PGEN COMMENTS ON EPA'S PROPOSED RULE: NESHAP COAL- AND OIL- FIRED ELECTRIC UTILITY STEAM GENERATING UNITS REVIEW OF THE RESIDUAL RISK AND TECHNOLOGY REVIEW

Docket ID No. EPA-HQ-OAR-2018-0794

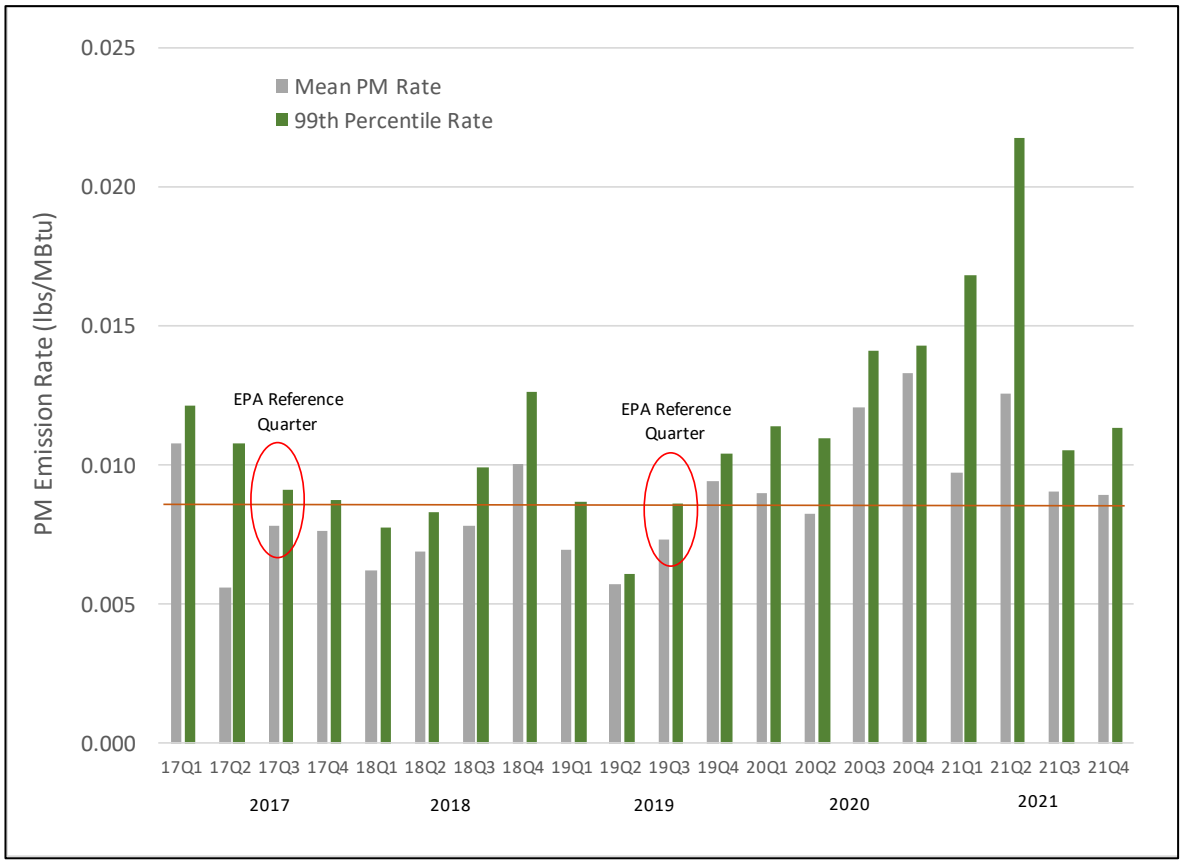
that EPA's analysis assumes that because a particular unit met this emission rate in one quarter under its current configuration, it must necessarily be able to meet it in every other quarter and indefinitely into the future. That is incorrect. The "actions individual EGUs have already taken to improve and maintain PM emissions" is not the only factor affecting fPM emissions. There is short-term and long-term inherent variability in the performance (emission rate) of any unit, due to myriad factors, including fuel variations, ash content, operating conditions, ambient conditions, load, duty, and many more. The variability of emissions within a quarter cannot possibly account for this longer-term variability. And again, while this statement is certainly true for units that use PM CEMS for compliance, it is even more emphatically so for units that use stack tests for compliance. The "variability" among three (highly-correlated) hours is certainly not indicative of variability during the 2,160 hours in that quarter, and much less the thousands of hours in other quarters and years.

Putting aside the unexplained and arbitrary nature of which years and which quarters in those years EPA selected for its analysis, the much larger problem with EPA's failure to consider all available data for the units in its database is that it led the Agency to ignore the long-term variability in units' performance. This is illustrated well in Figure 3-3 of the Industry Study (reproduced below), which shows both the average rates and 99th percentile rates for one EGU subject to the Proposed Rule for each of the 20 available quarters from 2017 to 2021.[49] The two quarters that EPA happened to look at for this unit were Q3-2017 and Q3-2019. EPA selected the latter as defining the "baseline" rate for the unit, a 99th percentile rate of 0.0086 lb/MMBtu. The long-term variability of this unit's performance is obviously much larger than EPA acknowledges (or, apparently, is aware of). The 99th percentile rates were higher than the baseline rate selected by EPA in 16 out of the 20 quarters available. Half of the quarters have 99th percentile rates that exceed the proposed standard of 0.010 lb/MMBtu.

Moreover, as the owner of the Coronado Generating Station explains in its own comments on the Proposed Rule, Q3-2019 was unusual and not at all representative of the units' operations most of the time.[50] Indeed, the Coronado units operated at very high capacity factors during Q3-2019, likely due to very high demand for power in Arizona that Summer, and that was likely the reason of a lower fPM emission rate for these units. Indeed, the Coronado units were base loaded during that quarter, operating 99.9% of all hours in Q3-2019, thus avoiding cold starts as well as frequent load changes. EPA's facile assumption – that the units must be able to consistently emit at less than 0.0086 lb/MMBtu (99 percent of the time) because they did so in Q3-2019 – is, therefore, divorced from reality. Nor can the performance of the Coronado units during Q3-2019 be ascribed to ESP maintenance that the units underwent before that quarter. The 99th percentile rate during the immediately following quarter (Q4-2019) was more than 0.0086 lb/MMBtu; in fact, it was more than 0.010 lb/MMBtu. Such an increase, so soon after the performance observed in Q3-2019, cannot possibly be explained by ESP maintenance activity. And that is true for every quarter from Q4-2019 to the end of 2021, each of which experienced a 99th percentile rate of more than 0.010 lb/MMBtu. Surely, the units underwent ESP maintenance during that period, yet the fPM rate was never as low as Q3-2019. Indeed, the ESP maintenance activities

Mercury Content Variability for Eight Lignite Suppliers in North Dakota[121]

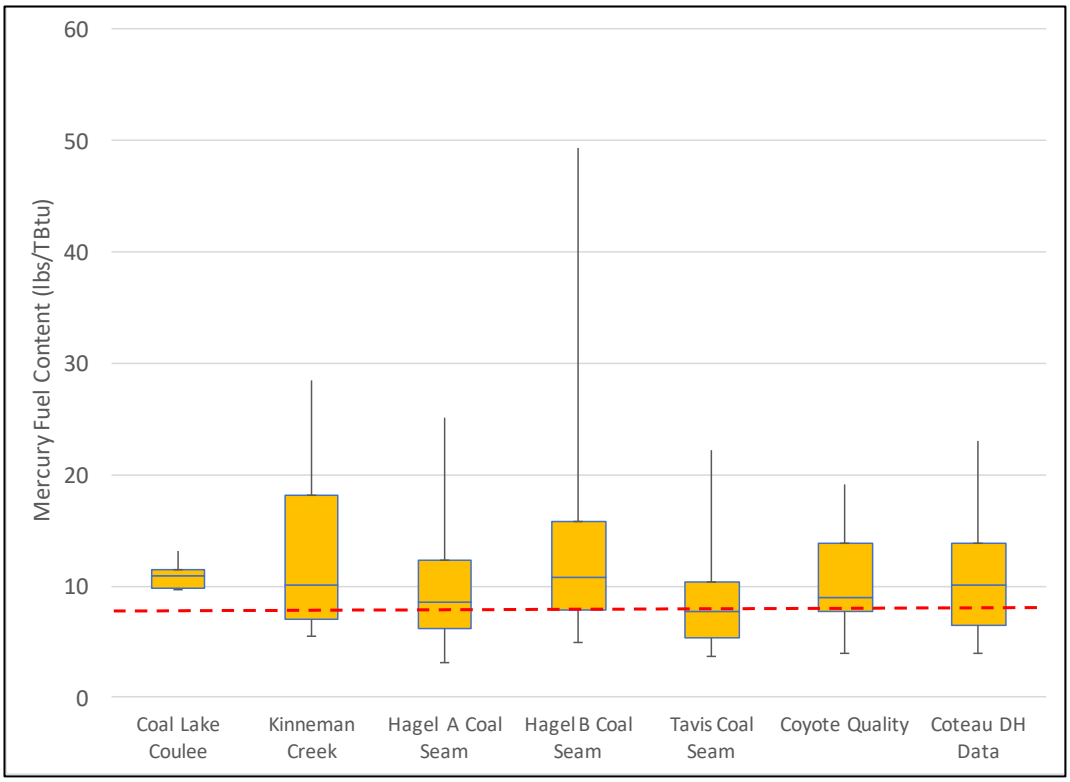
EPA's proposal to lower the Hg standard for lignite-fired EGUs ignores the complete chemical composition of lignite-coal and technical challenges in Hg control technologies for EGUs firing lignite coal. EPA ignores the wide variability of Hg content, sulfur content, and alkalinity of inorganic matter in Fort Union (North Dakota) and Gulf Coast Lignite.

EPA assumes an average Hg content for Fort Union lignite of up to 7.8 lb/TBtu.[119] That assumption is not supported by any test data – EPA's analysis relies solely on the Integrated Planning Model ("IPM") assigned inlet Hg content value of 7.81 to derive an 85 percent Hg control rate to meet a 1.2 lb/TBtu standard.[120] As shown in the figure below, actual chemical composition tests for lignite from Fort Union mines in North Dakota show a substantial Hg content variability within each mine.

The data reported in the figure above also show how high the Hg content of North Dakota lignites typically is: the 75th percentile of data from each lignite supplier significantly exceeds EPA's value of 7.8 lb/TBtu by a substantial margin. For one North Dakota lignite mine, the 75th percentile Hg content is upwards of 18 lb/TBtu, more than double EPA's assumption.[122] Based on these actual Hg content data for North Dakota lignite mines, achieving a 1.2 lbs/TBu requires an Hg removal rate of approximately 93-95% for unavoidable instances where lignite Hg content is at the 95th percentile of observed values.[123] Such high removal efficiencies cannot be achieved by sorbent injection. And, they certainly cannot be achieved given the other chemical composition differences between lignite and PRB coals, as discussed in subsection B, below.

Figure 3-2. Numbers of Quarters Sampled by EPA for Use in PM Database

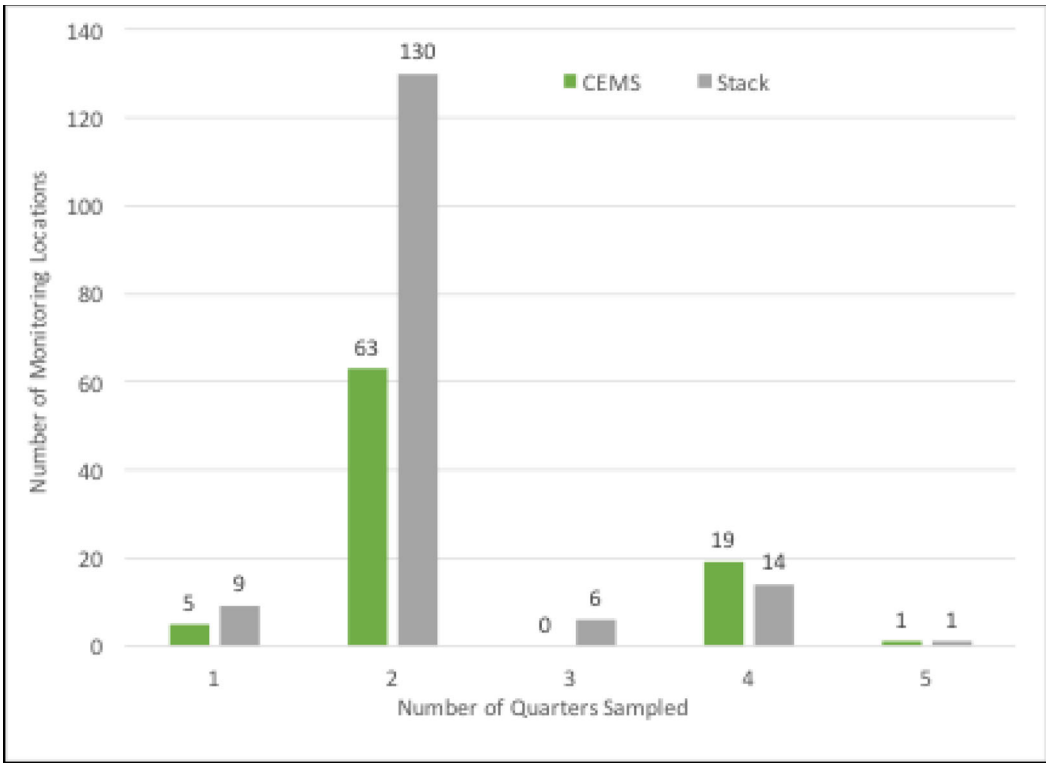
Figure 3-2 shows most monitor locations — 193 of the 245 — are characterized by only 2 quarters of data, which is inadequate compared to the 16 or 20 EPA has access to. The distribution of quarters selected by EPA according to either CEMS or stack test measurement for all 245 locations is shown. The second largest category is 33 units characterized by 4 quarters.

Of concern is the limited subset of data used for this analysis – Figure 3-2 showed that for 80% of the units the lowest is selected from only two samples. EPA states "By using the lowest quarter's 99th percentile as the baseline, the analyses account for actions individual EGUs have already taken to improve and maintain PM emissions."[11] EPA states employing the PM rate at the 99th percentile –reflecting approximately the highest data within that quarter – remedies any bias.[12]

Figure 3-3. Coronado Generating Station: 20 Operating Quarters

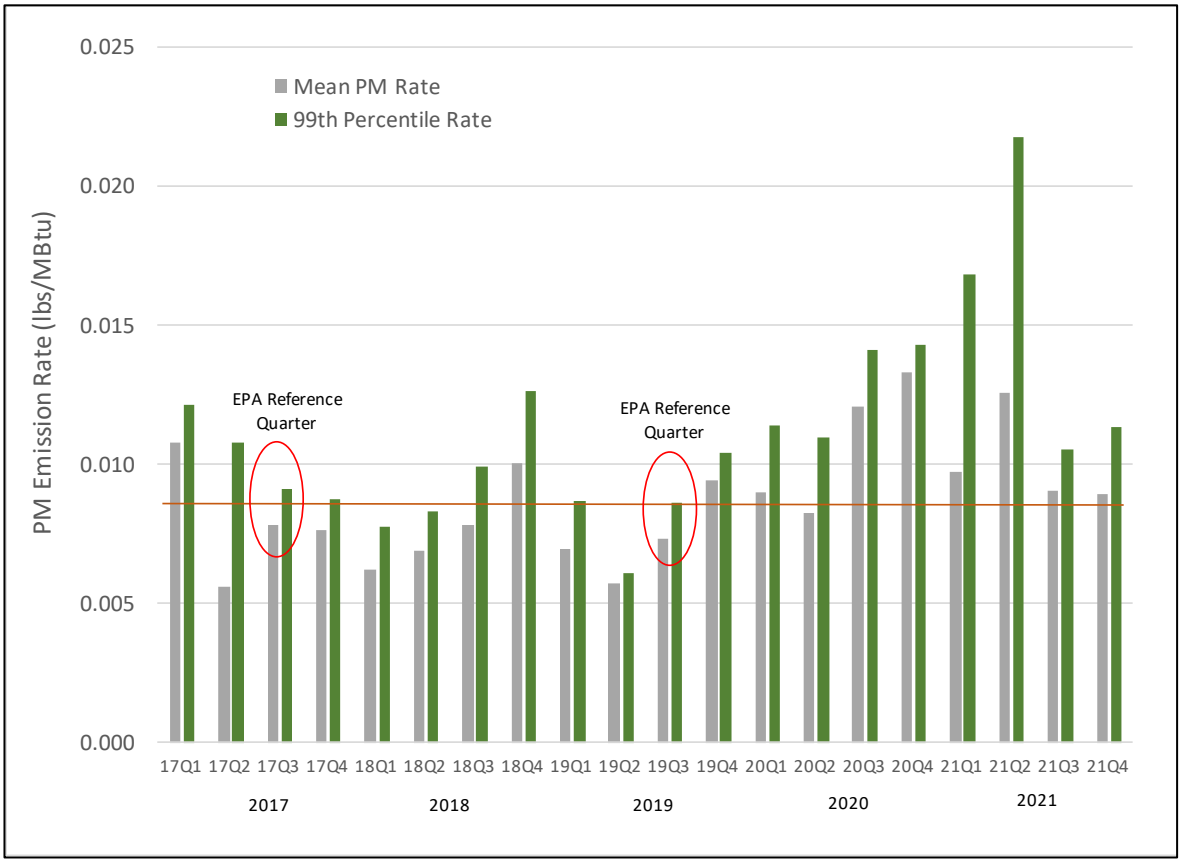
Figure 3-3 presents an example that demonstrate the shortcomings of EPA's approach. Figure 3-3 presents PM data from Coronado Generating Station Units 1 and 2 reflecting all operating quarters from 2017 through 2021. Both the average PM rate and the 99th percentile from each quarter are presented for 20 quarters of operation over the 4-year period. Figure 3-3 also identifies the two samples EPA selected from 2017 Q3 and 2019 Q3 as representative of low fPM rate, with the latter as the "least" – and the 99th-percentile reporting 0.0086 lbs/MBtu. Figure 3-3 shows EPA's two samples do not capture the full character of Coronado operating duty (with the red dotted line denoting the PM rate selected as representative of the units'

capabilities to control PM). These quarters as selected by EPA are far from representative of unit operations or capabilities: among 20 quarters for which data are available, the units' 90th percentile fPM rates exceed the 0.0086 lbs/MBtu rate EPA selected for 16 quarters. Ten out of 20 quarters showed 90th percentile fPM rates exceeded the proposed standard of 0.010 lb/MBtu.

Coronado Units 1/2 show how selecting the least PM rate of any quarter, and adopting the 99th percentile PM rate within that quarter, does not capture the variability in fPM emission rates, which are affected by the variability of coal and operating conditions, among others. These examples demonstrate that EPA used best-case fPM data from both compliance measures (continuous monitor and performance test data).

Figure 6-1. Mercury Content Variability for Eight North Dakota Lignite Mines

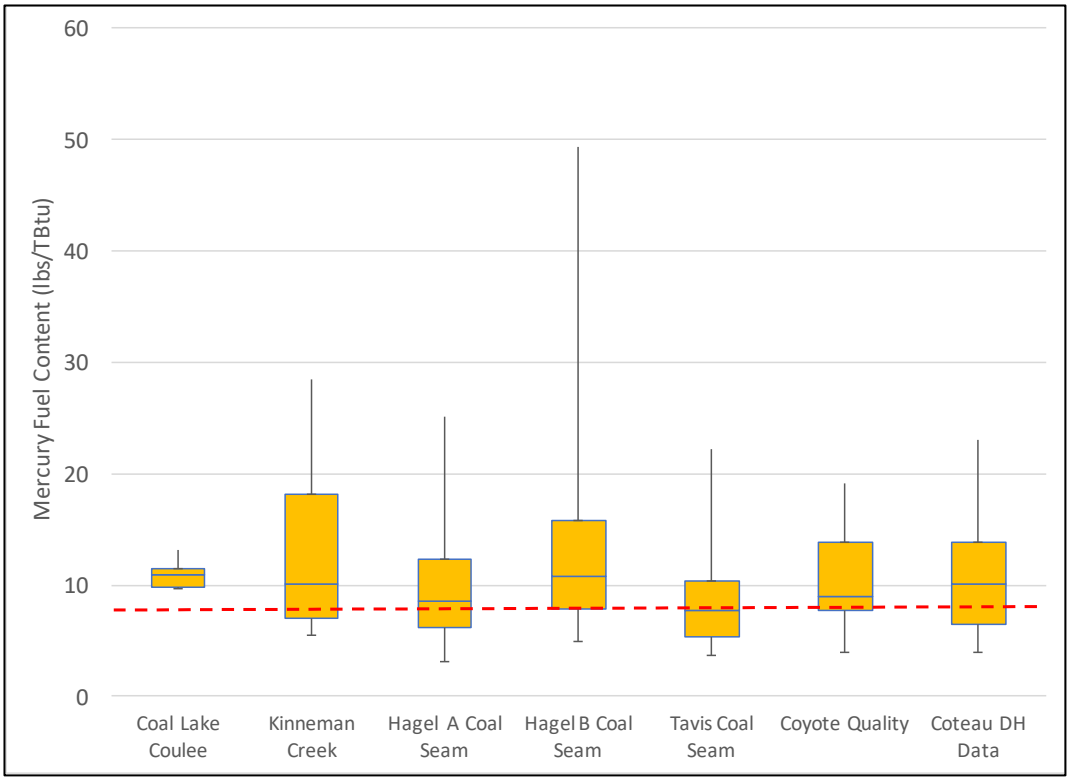
Figure 6-1 compares the Hg content and variability to the fixed value of 7.7-7.8 lbs/TBu, assumed by EPA as representing North Dakota lignite, as summarized in Table 11 of the Tech Memo. Figure 6-1 shows – with the exception of the Tavis seam – all mean values of Hg content exceed EPA's assumed value that serves as the basis of EPA's evaluation. More notably, the 75th percentile value of Hg for each seam - slightly more than one standard deviation variance from the mean – in all cases significantly exceeds the value assumed by EPA.

Of note is that the variability of Hg depicted in Figure 6-1 is not necessarily observed only over extended periods of time – such as months or quarters – it can be witnessed over period of days or weeks. This is attributable to the sharp contrast in Hg content of seams that are geographically proximate and thus are mined within an abbreviated time period. Figure 6-4 presents a physical map showing the location of "boreholes" in a lignite field with imbedded text describing (in addition to the borehole code) the Hg content as ppm. The text boxes report this Hg content in terms of lbs/TBtu. These example boreholes – separated by typically 660 feet- and the factor of 3 to 6 variation of Hg content present a meaningful visualization of Hg variability in a lignite mine, and the consequences for the delivered fuel.

Figure 6-3. Fuel Alkalinity/Sulfur Ratio for Eight North Dakota Mines

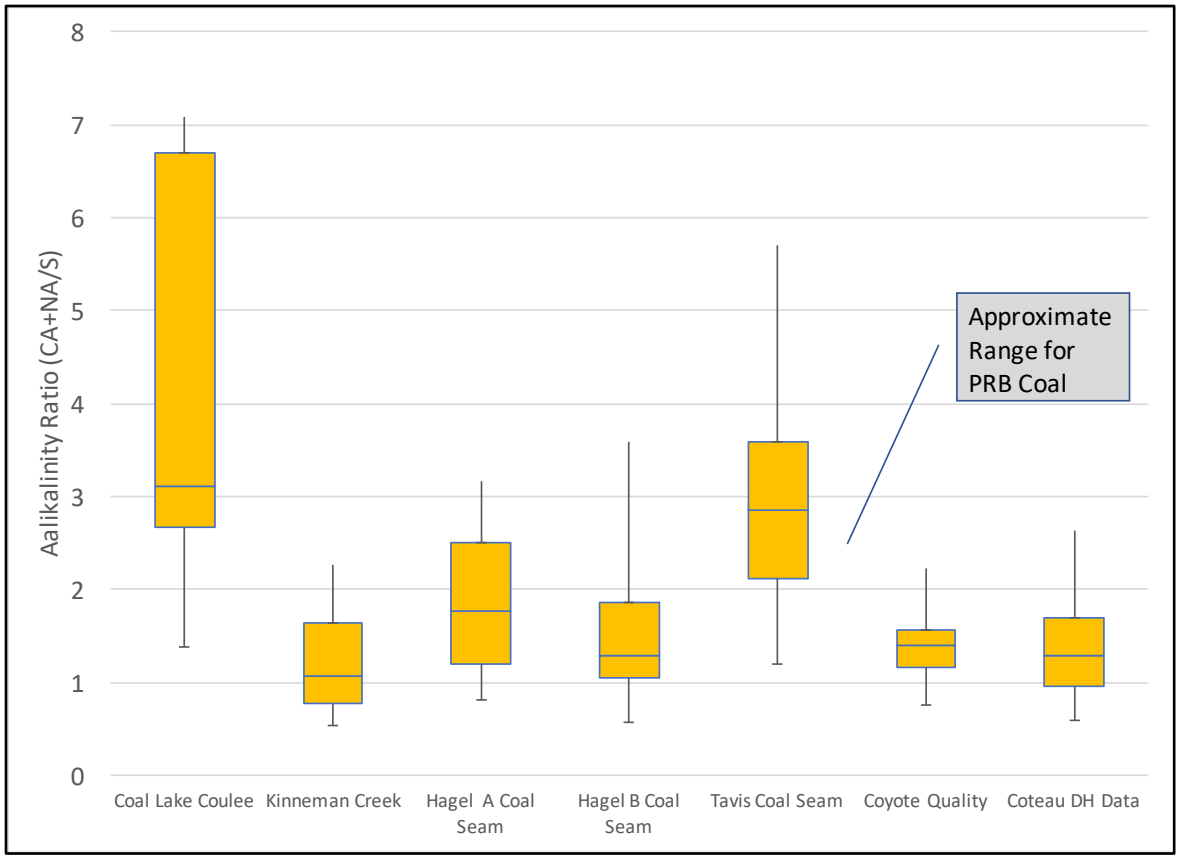
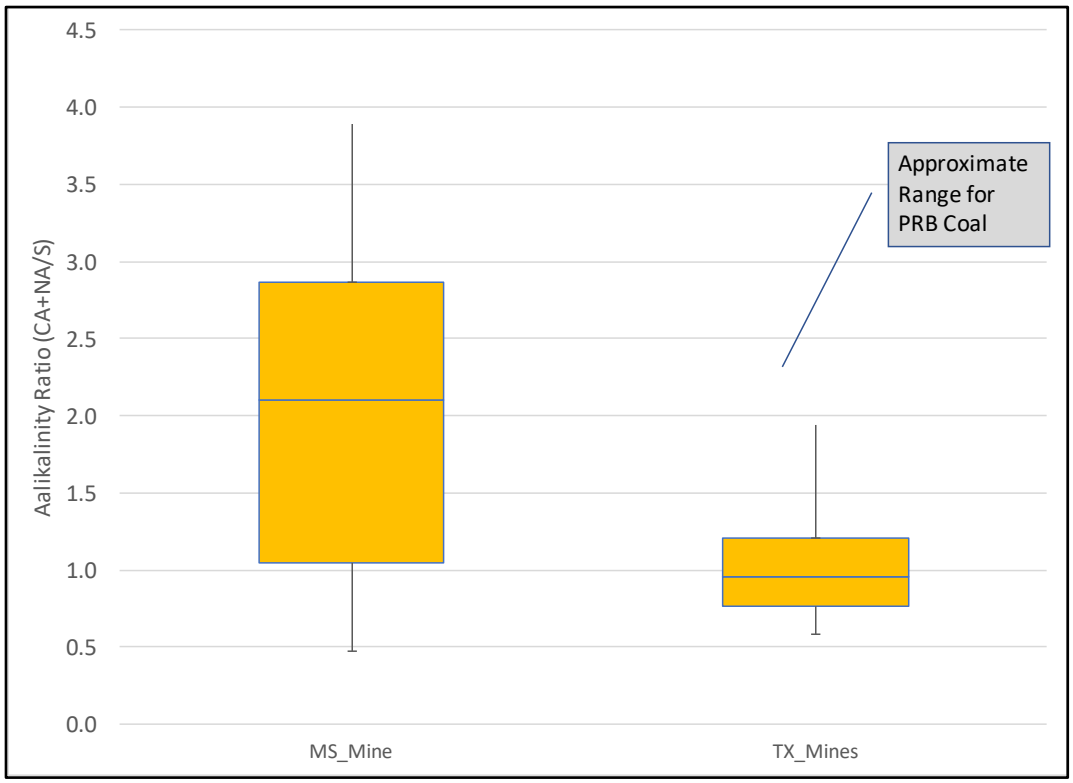
Figures 6-3 and 6-7 show North Dakota and Gulf Coast lignite present a similar ratio of alkalinity to sulfur content as does PRB – approximating a value of 2. By this metric, lignite fuels in Figure 6-3 present similar means to "buffer" SO_3 as PRB. Notably, Texas lignite in Figure 6-7 is disadvantaged in this metric as the alkalinity to sulfur ratio is half that of PRB – reducing the buffering" effect of inherent ash.

Figure 6-5. Mercury Variability for Two Gulf Coast Sources: Mississippi, Texas

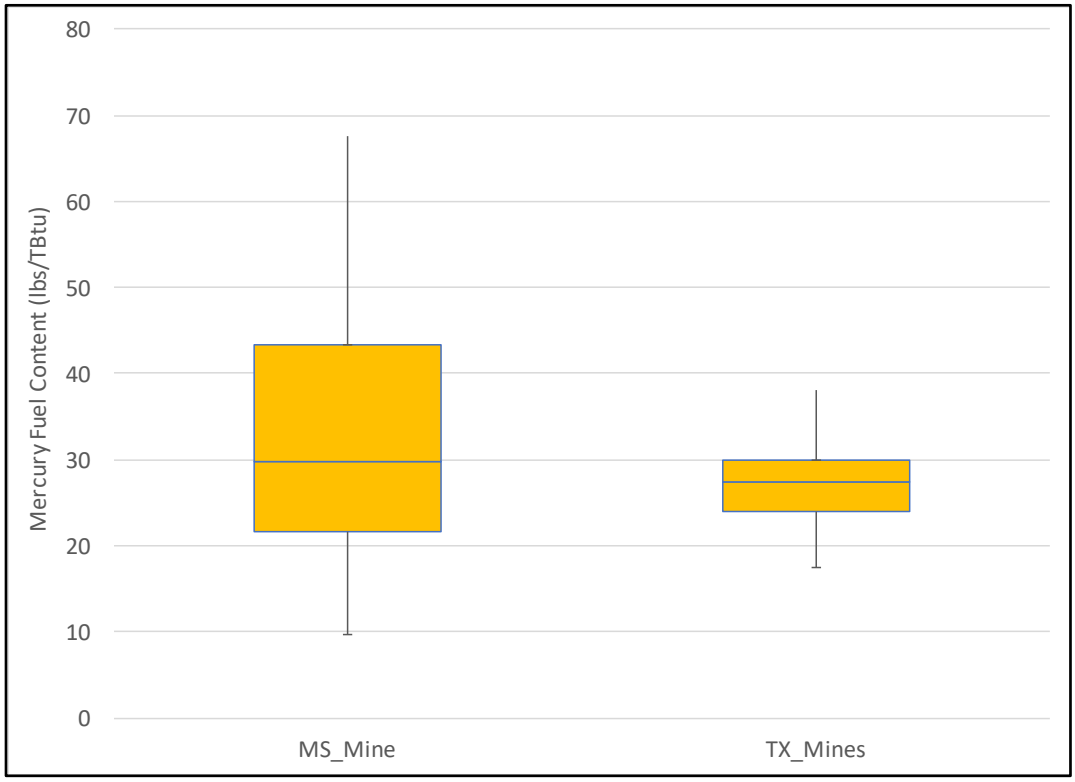
Table 6-2 compares the Hg removal required to meet the proposed 1.2 lbs/TBtu rate considering the variability of Hg in Texas and Mississippi coals, instead of the IPM-assigned Hg coal content. For three Texas plants that fired 100% lignite – Major Oak Units 1 and 2, Oak Grove Units 1 and 2, and San Miguel – EPA assigned inlet Hg values from 12.44 to 14.88 lbs/TBtu, implying Hg removal of 90-92% to achieve 1.2 lbs/TBtu. However, based on the 95th percentile value of the Texas lignite Hg values from Figure 6-5, the required Hg removal would be 96-97%.

Figure 6-8. Lignite Hg and Sulfur Content Variability: 2021 EIA Submission

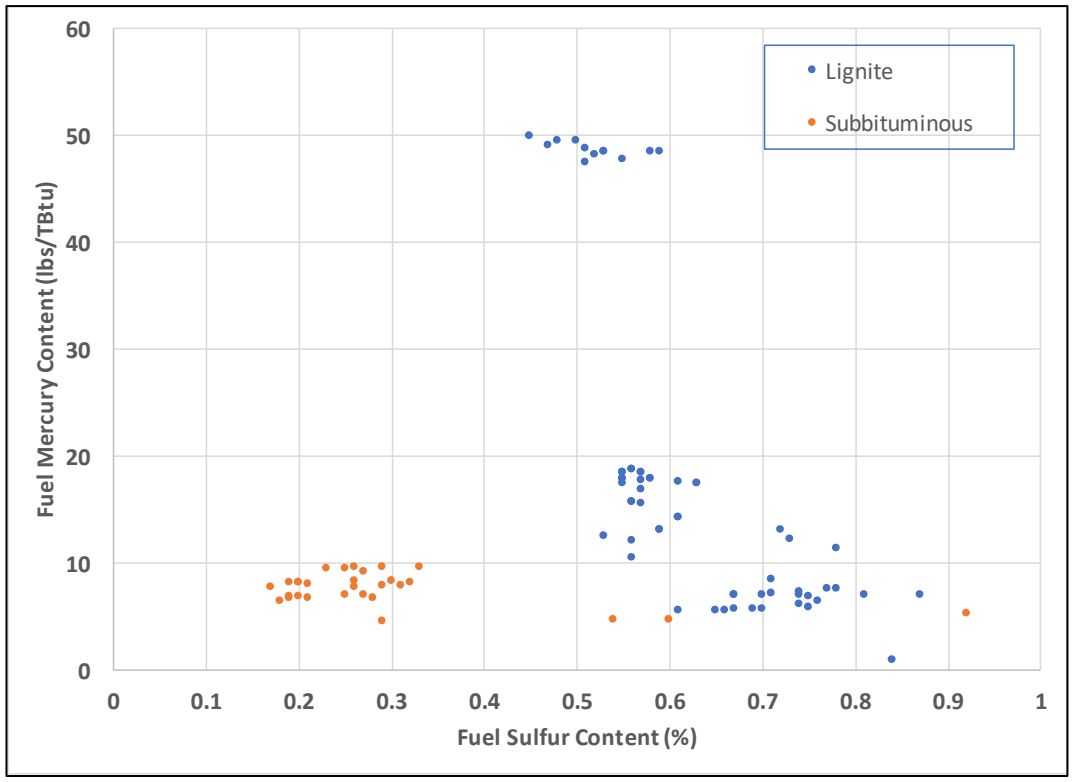
Figure 6-8 compares the seam-by-seam Hg and sulfur content from various power stations firing lignite coals, representing approximately 60 lignite mines and 40 PRB mines. Figure 6-8 shows, even excluding the outlier values of Hg (approximating 50 lbs/TBtu), lignite presents significantly greater variability in Hg and sulfur than PRB. Moreover, lignite coals have a much higher sulfur content than PRB and in many instances have twice the Hg content. The higher sulfur content of lignite equates to greater production rates of sulfur SO_3.
